City of Detroit
Inter-Departmental Communication

RE: **Petition No. 1821-revised**
Request to Outright Vacate Various Streets And Alleys And Encroachment Into
Monroe And A Portion Of Cadillac Square In The Area Bound By Monroe,
Randolph, Bates, And Cadillac Square

NOTICE OF PROPOSED CHANGE IN PROPERTY

REQUEST TO OUTRIGHT VACATE AND
 CONVERSION TO EASEMENT
 VARIOUS PUBLIC STREETS AND ALLEYS AND
 REQUEST ENCROACHMENTS OF
 MONROE AVE, A PORTION OF BATES ST. AND CADILLAC SQ.
 IN THE AREA BOUND BY
 MONROE AVE, RANDOLPH AND BATES ST.
 AND CADILLAC SQUARE

PETITION 1821
 MONROE BLOCK TEMPORARY EARTH
 RETENTION TIE-BACK ENROACHMENTS
 REVISED 1/31/2018

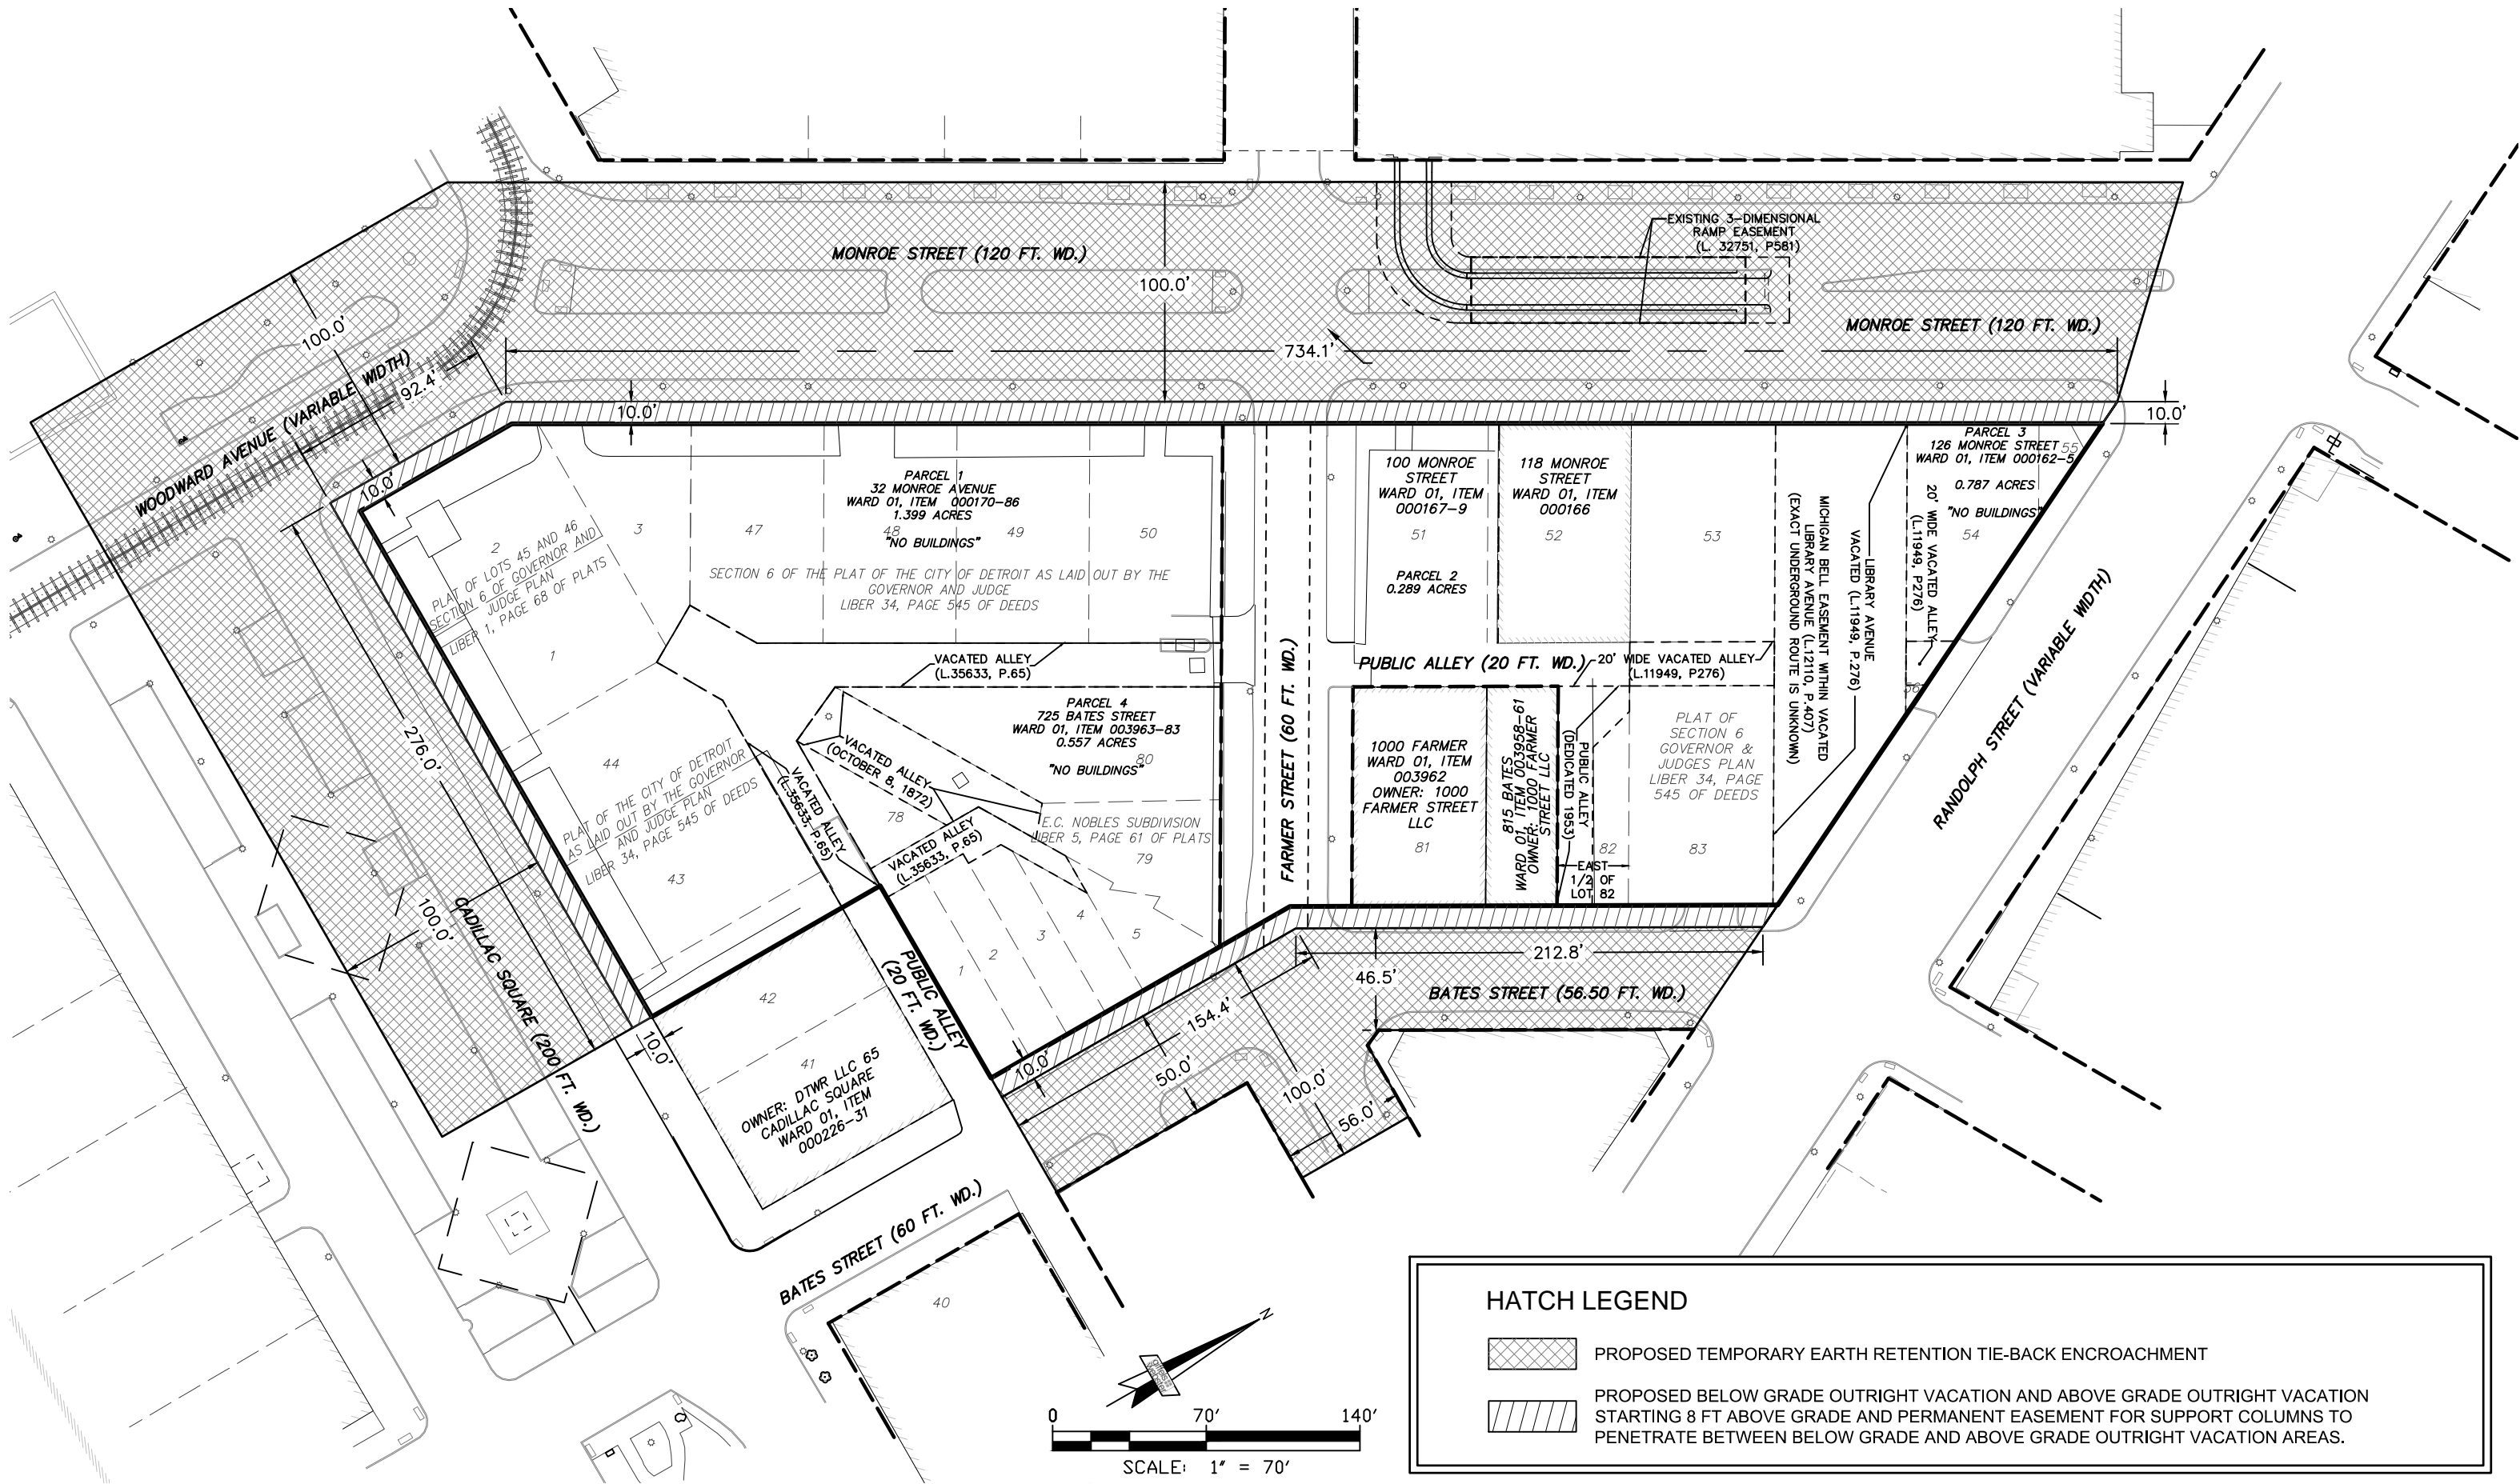
Page2: We added the 2D extents of the temporary tie-back encroachments
